Groundwater Remedy Phase 2A Construction, PG&E Topock Compressor Station, Needles, California

Work Variance Request #12 – Proposed addition of pipelines/conduits to connect existing extraction well TWB-3 and deferral of the Operations Building on the Transwestern Bench

Variance Request No.: 12

Date

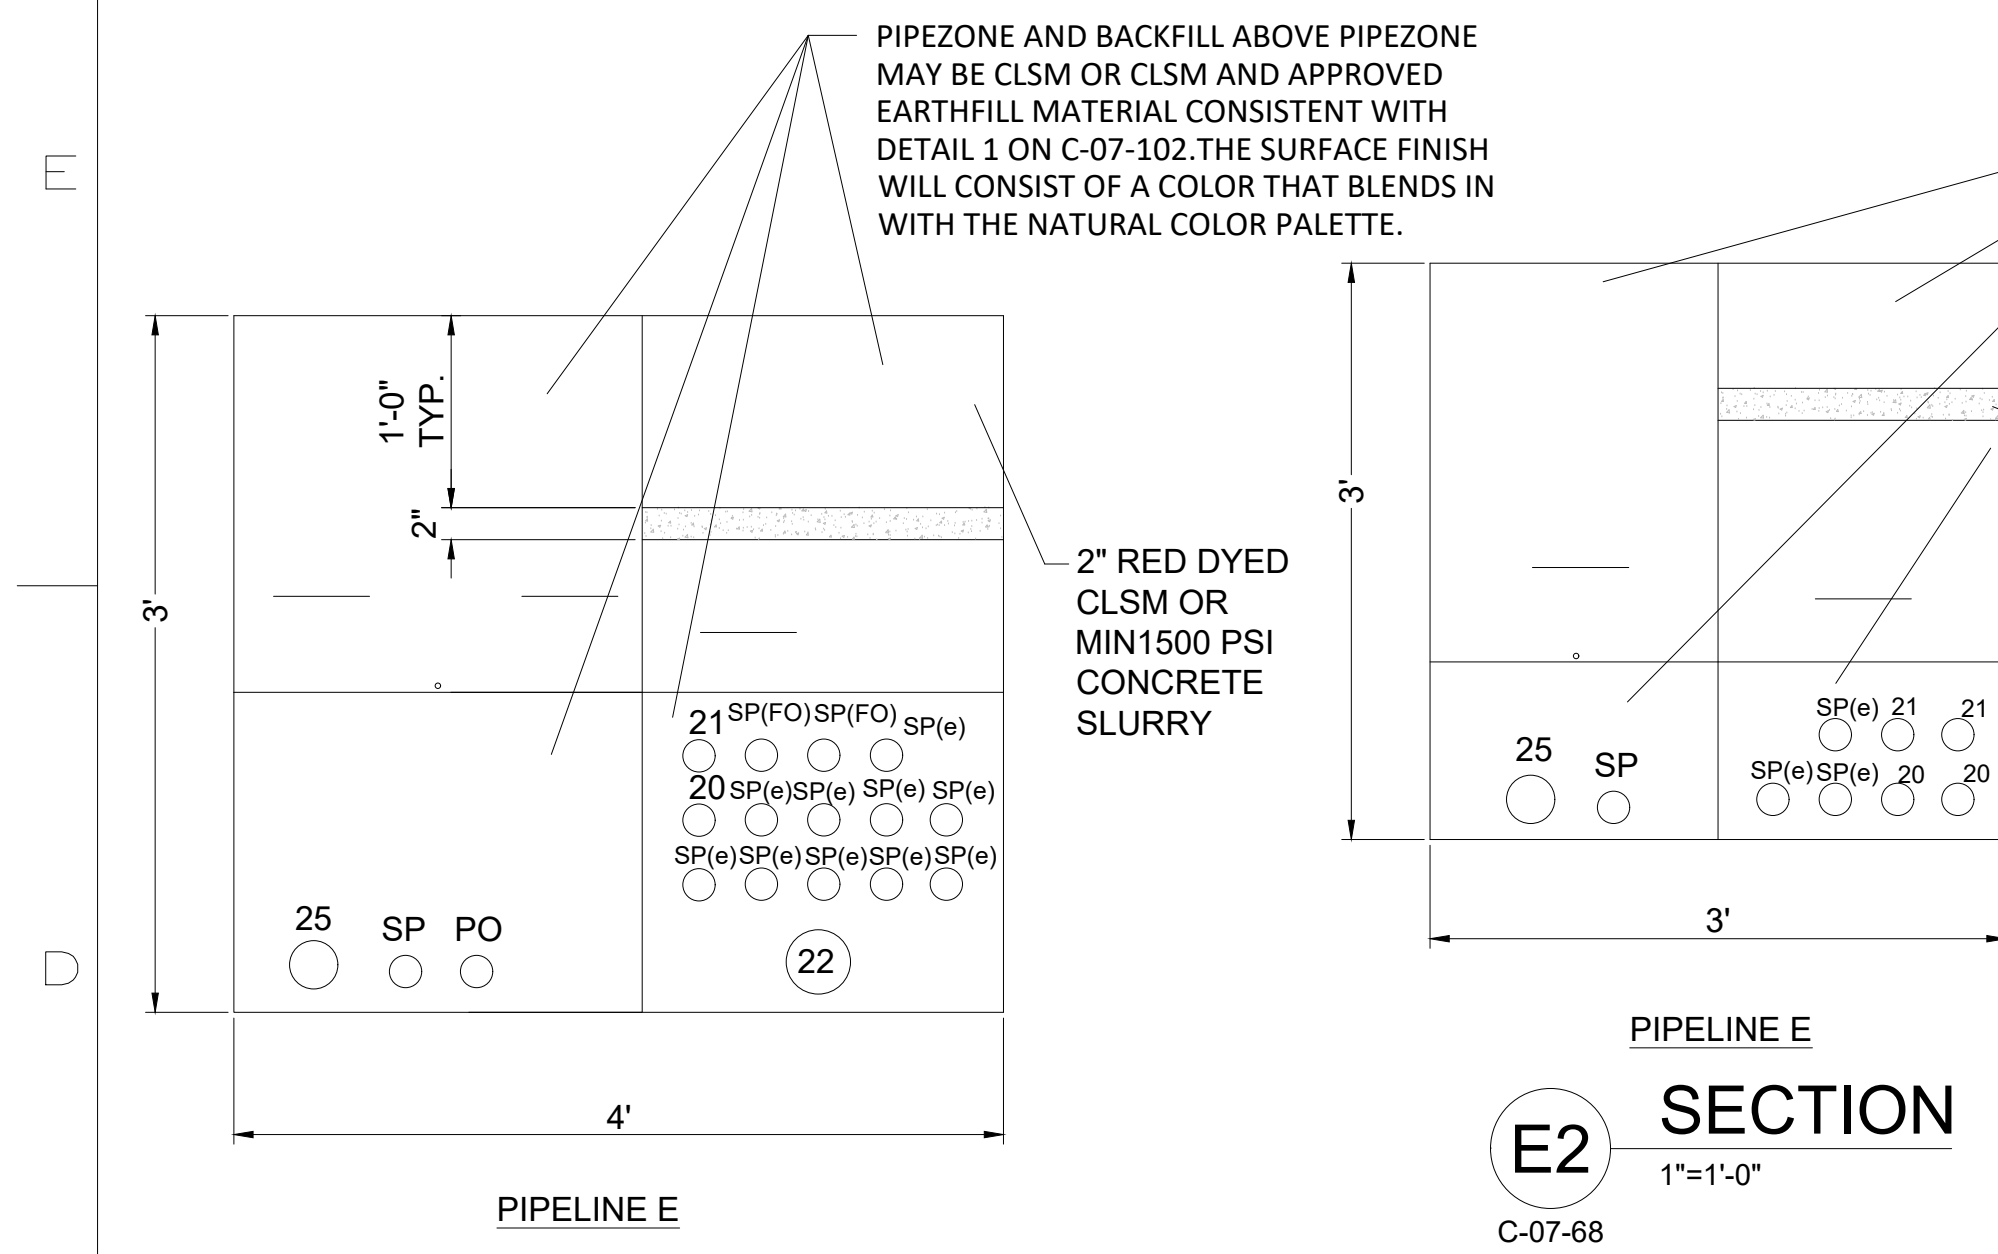
The plan and profile of the new pipeline is shown in the attached drawing C-07-60. The trench sections E3 and E3-Alt are shown in attached drawing C-07-106. Below is a summary of key construction details:

- A trench of approximate dimension of 2 feet wide by 3 to 4 feet deep by 470 feet long will be installed from existing well TWB-3 to existing well TWB-1. The actual dimension of the trench may vary depending on field conditions.

- Within the trench, there will be two High Density Polyethylene (HDPE) pipes (2 or 3 inches in diameter by 470 feet long) and three conduits (2 inches in diameter by 470 feet long). Where the trench crosses over PG&E gas pipeline, one pipe sleeve (approximately 4 inches in diameter by 20 feet long, actual dimension may vary depending on field conditions) will be used to contain the HDPE pipes. Therefore, the total pipe length is $2 \times 470 + 1 \times 20 = 960$ feet and total conduit length is $3 \times 470 = 1,410$ feet.

MICROFILM	
BILL OF MATL.	
DWG LIST	
SUPSDS	
SUPSD BY	
SHEET NO.	of SHEET
C-08-02	REVISION

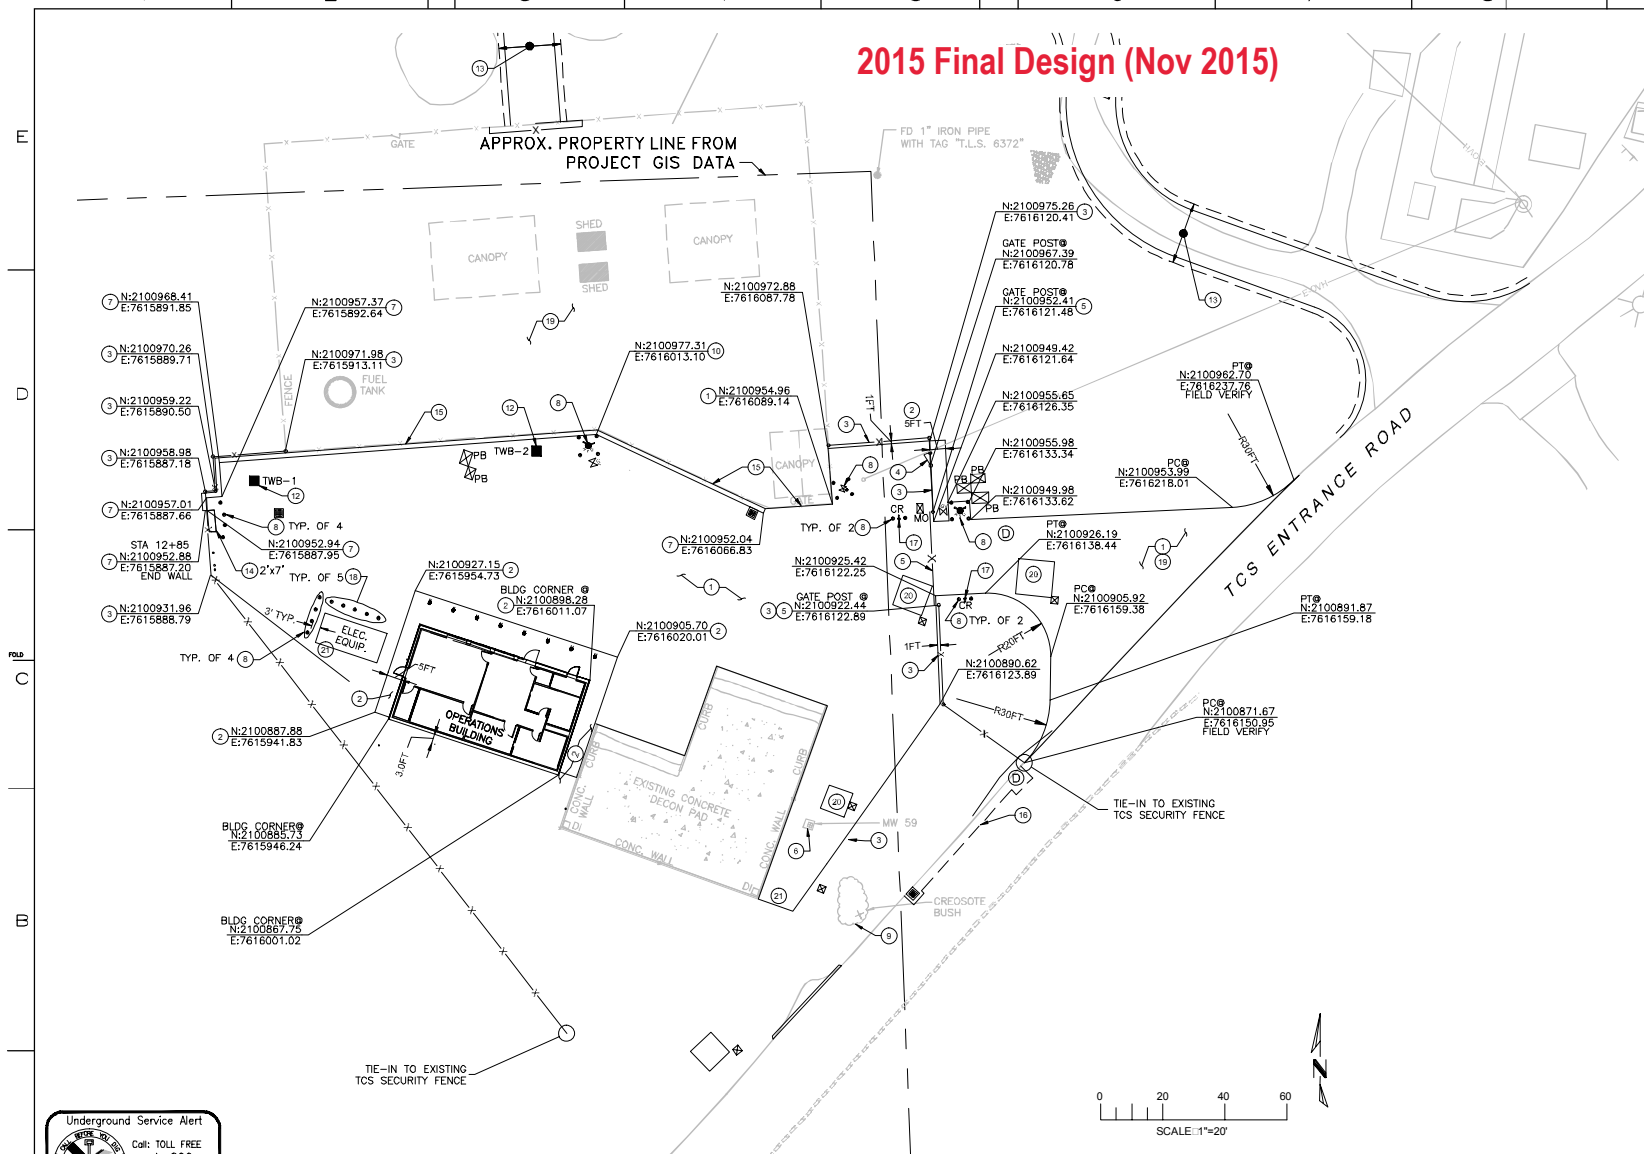
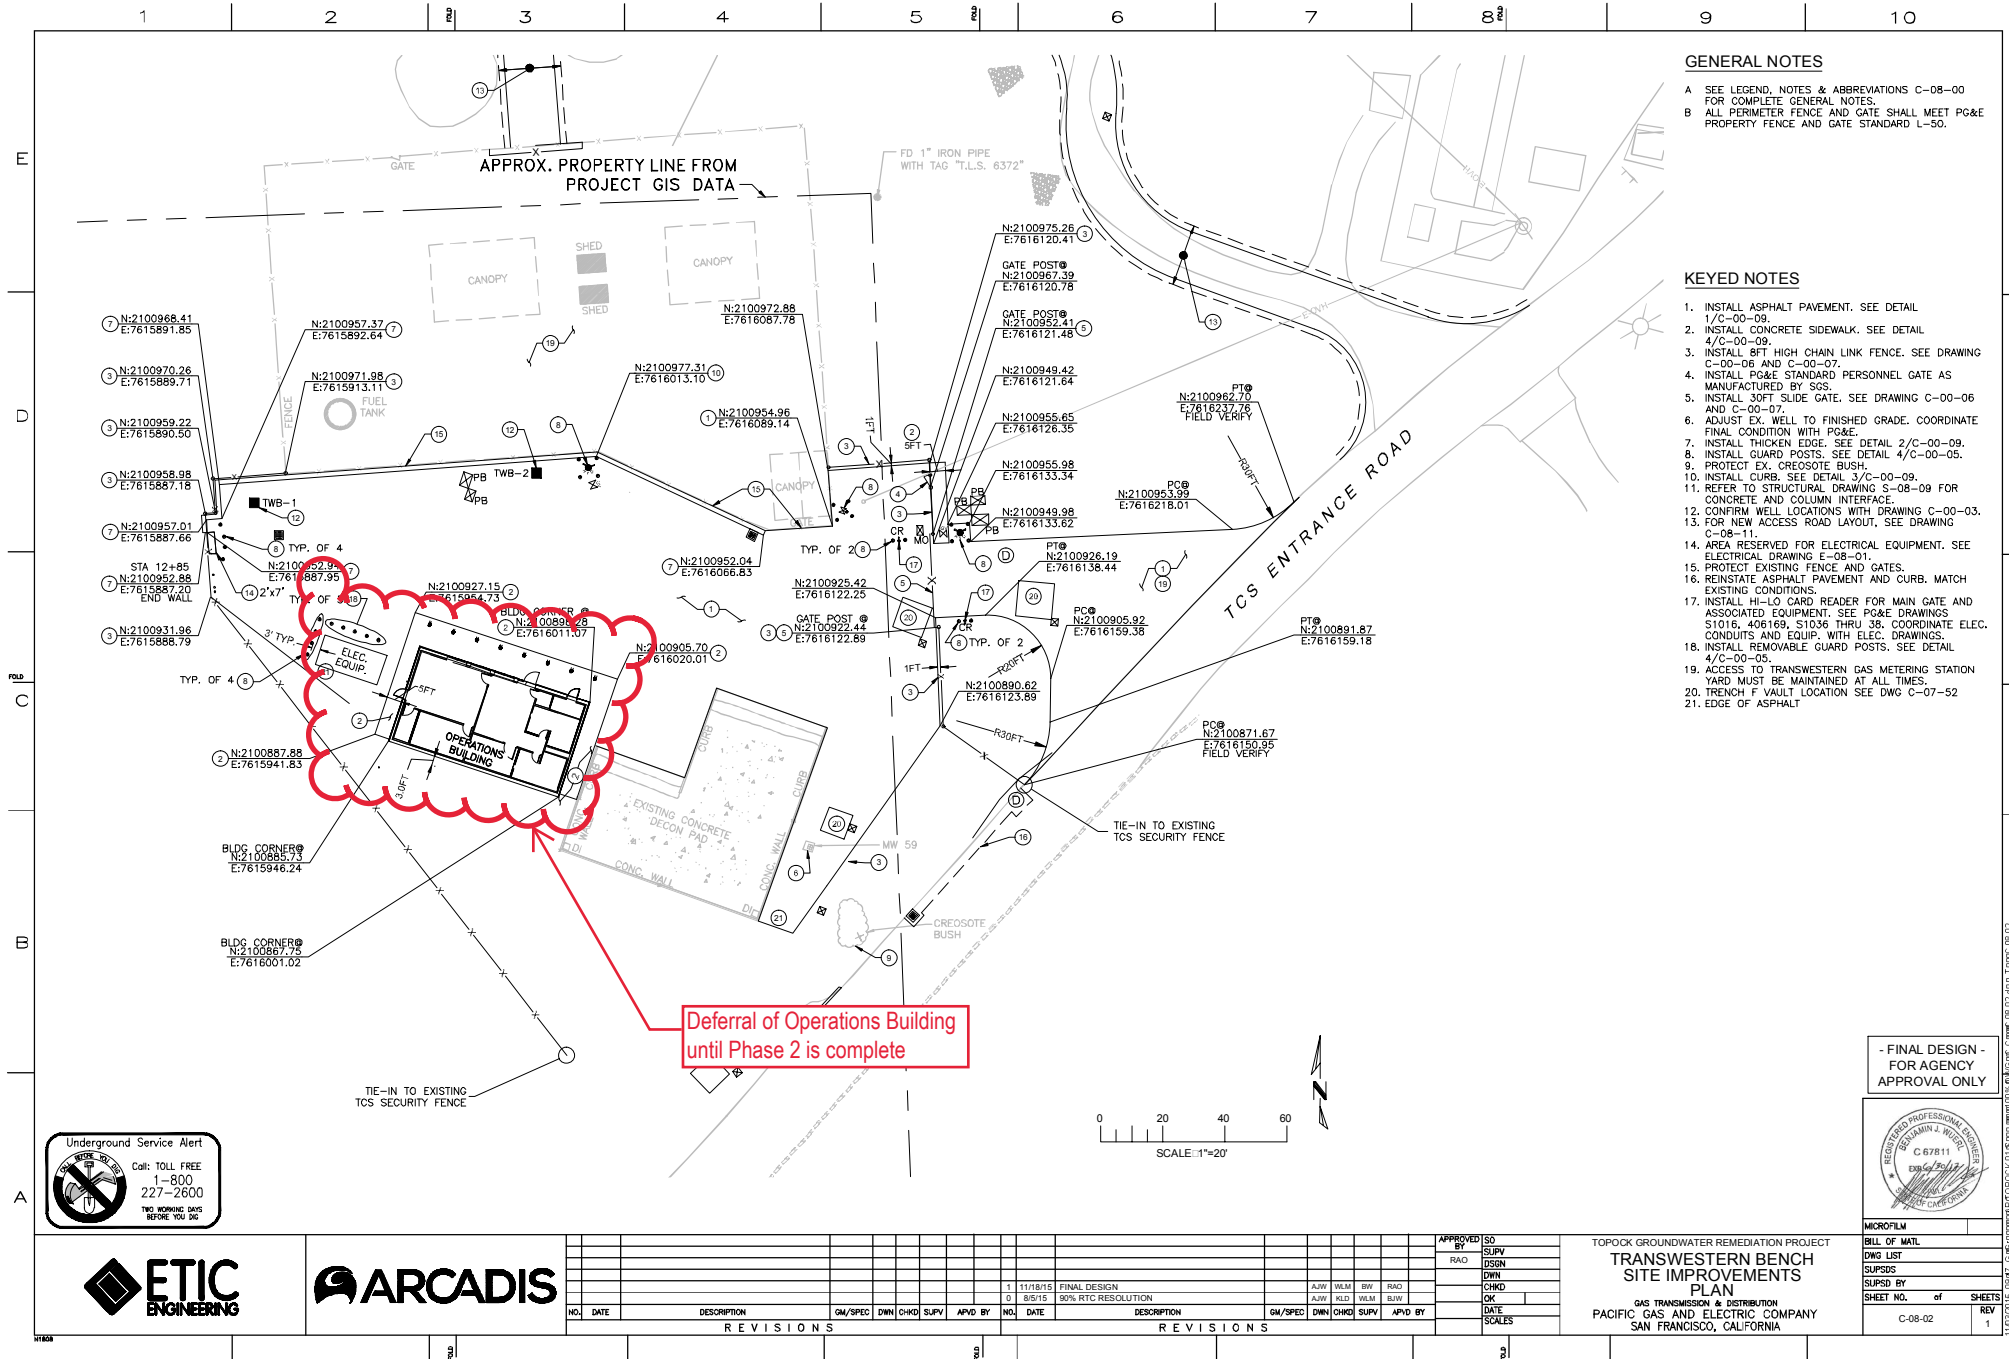
- b) Defer construction of the Operations Building at the Transwestern Bench.** The current use of the Carbon Amendment Building to house the electronical hardware (e.g., Programmatic Logic Controller [PLC]), the conex boxes in the CHQ for equipment/spare parts storage, and the offices in the SPY trailer for O&M workers negate the need for the Operations Building on the Transwestern Bench at this time.
